Staff Report

JOHNSON RIDGE PLANNED RESIDENTIAL DEVELOPMENT & PRELIMINARY PLAT

To: Planning Commission
From: Nikole Coleman, Associate Planner
Date: June 16, 2020
Subject: Johnson Ridge Planned Residential Development & Preliminary Plat | P-08-02-19-01

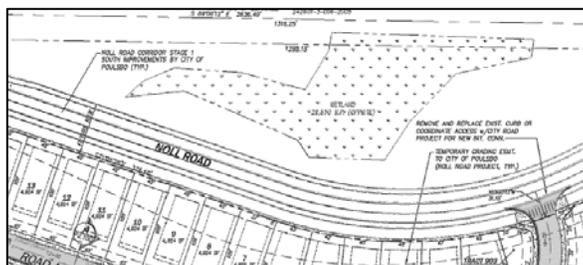
A. Off-Site Wetland. A Wetland Delineation Report prepared by Ecological Land Services (Exhibit F.1) was prepared for this project. Wetland A is a .62-acre Category IV. Per page 2 of the Ecological Land Services report (Exhibit F.1), “One wetland, Wetland A, was identified and delineated at the north edge of the property. Wetland A is a narrow sloping emergent system that continues onto the adjacent north property. The onsite portion of the wetland is un-mowed and dominated by reed canarygrass. The offsite portion is mowed as a part of the offsite pasture. A narrow, seasonal stream flows through the offsite wetland area and down the ravine slopes into Bjorgen Creek.”

The image to the left shows the extent of wetland A and the 50-foot buffer.

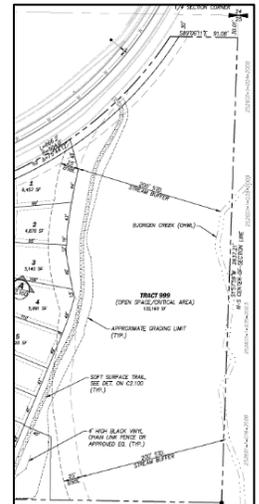
B. Bjorgen Creek. Bjorgen Creek is a type F1 stream requiring a 200-foot buffer and 25-foot building setback. A Habitat Management Plan prepared by Ecological Land Services (Exhibit F.3) was provided for this project. Per page 5 of the Ecological Land Services report (Exhibit F.3), “Bjorgen Creek is confined to the bottom of the steep-sided ravine on the east side. There are terraces along the slope and very steep slopes down between the terraces. The steepest section of the slope is the lowest section that extends down to Bjorgen Creek. The ravine slopes are composed of a mixed coniferous and deciduous

forest with a sparse shrub layer and often nonexistent herbaceous layer.” The location of Bjorgen Creek and the extent of the 200-foot buffer are shown in the image to the right.

The initial application submittal requested a 25% reduction in the 200-foot stream buffer. Per PMC 16.20.315 B, the director may decrease the standard buffer or building setback as recommended by a habitat management plan after consultation with the Washington State Department of Fish and Wildlife and the Suquamish Tribe, and determine that conditions are sufficient to protect the affected habitat. A habitat management plan shall be required. The director may reduce the buffer or building setback width by up to twenty-five percent, but the buffer width shall not be less than fifty feet.

These two comments were provided to the applicant and the project was revised and a request to reduce the 200-foot stream buffer was abandoned.

The project proposal was revised and now only includes grading impacts at the back of Lots 1 through 5 that will total 8,772 square feet and a portion of the trail is proposed within the 200-foot buffer area and will comprise 1,474 square feet of the buffer. The project buffer impact area is shown in green in the image to the right. Restoration is proposed to compensate for the impacts and will include installation of native trees and shrubs. The trail will be a 5-foot wide, gravel pedestrian trail within the outer edge of the 200-foot buffer per the PMC requirements.

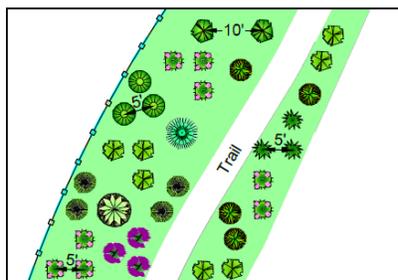
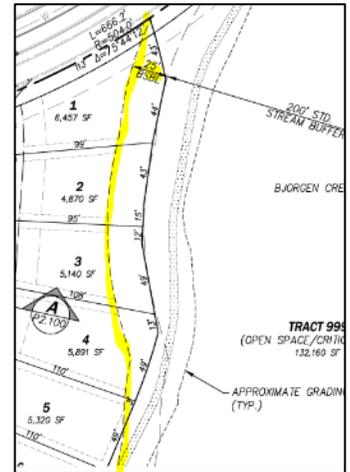
The images below show the proposed restoration to compensate for the impacts from the trail and will include installation of native trees and shrubs.

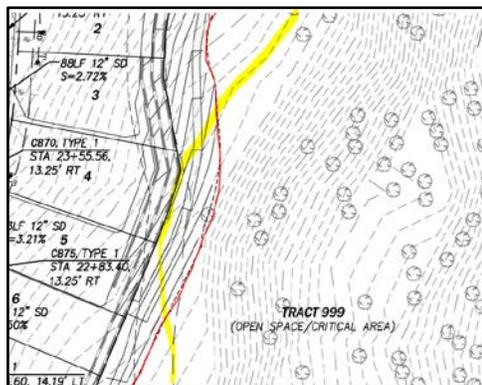
Based on the proposed Site Plan prepared by CPH Consultants, a small portion of the pervious trail and grading are proposed within the 25-foot standard setback area.

The yellow highlighted area in the image to the left shows the 25-foot standard setback. The red line shows the extent of the construction area.

An addendum to the Geotechnical Report (Exhibit G.7) was requested by staff and provided in order to address this encroachment. Per page 1 of the GeoResources Addendum, “We analyzed a new cross section (Du-Du’) through the areas where grading will encroach into the required 25-foot buffer. The area is generally limited to slope below proposed lots 3, 4, 5, and 6 on the east side of the development. A series of three walls will provide additional grade separation in this area, with grades being raised up to about 16 feet across these 4 lots. In our original report, slope stability section D-D’ was south of where the grading will occur within the buffer. As stated, we drew a cross section through Lot 4, where the greatest amount of fill will be placed. Using the same methodology and soil parameters described in our

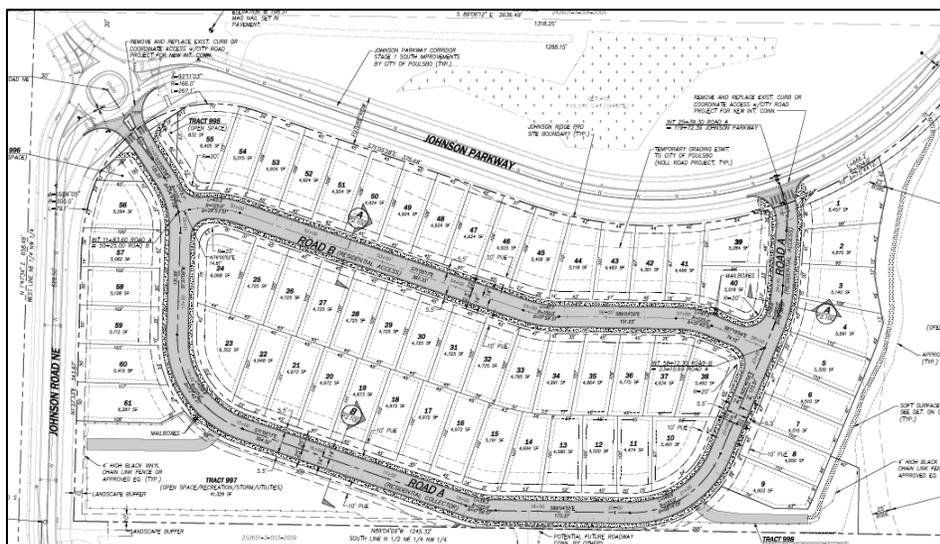
Sound Urban Forestry provided peer review of the tree retention plan (Exhibit G.2) and a number of comments were provided, including:

determine the minimum required retention. I am recommending this area be surveyed since these trees will count toward the total saved.”

- “Trees that are to be retained should be clearly identified on the Tree Retention Plan so that they can be easily found on the site. The table states that 43 trees are to be retained but the number of trees shown with that symbol do not match that number.”
- “It is the responsibility of the applicant to show that the trees proposed for retention are healthy enough so that they have a reasonable chance of survival once the site is developed. No information has been presented on the trees to be retained.”

An Arborist Report prepared by Layton Tree Consulting, LLC (Exhibit G.1) was submitted with project revisions in November 2019. Sound Urban Forestry provided a second peer review (Exhibit G.2) of the tree retention plan and Arborist Report and stated “Overall, the arborist report is thorough and is what should have been submitted with the initial package. As requested in my original memo, all trees within the site have been accounted for and assessed with the information clearly presented. The tree protection measures outlined are appropriate and I recommend that they be considered conditions of approval by the City.”

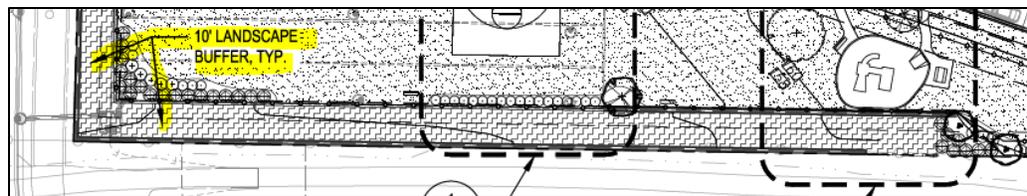
The storm vault on the SW corner of the development proposes a 12-20-foot exposed retaining wall to be visible from the property to the south and the future Johnson Parkways (coming from SR305) (as shown below).

The Engineering Department has worked with a committee to determine the aesthetic scheme for the Johnson Parkway project. On-site improvements, including retaining walls, landscaping, signage and lighting, along adjacent to the future Johnson Parkway shall include enhanced landscaping and/or artwork to break up the size of the walls.
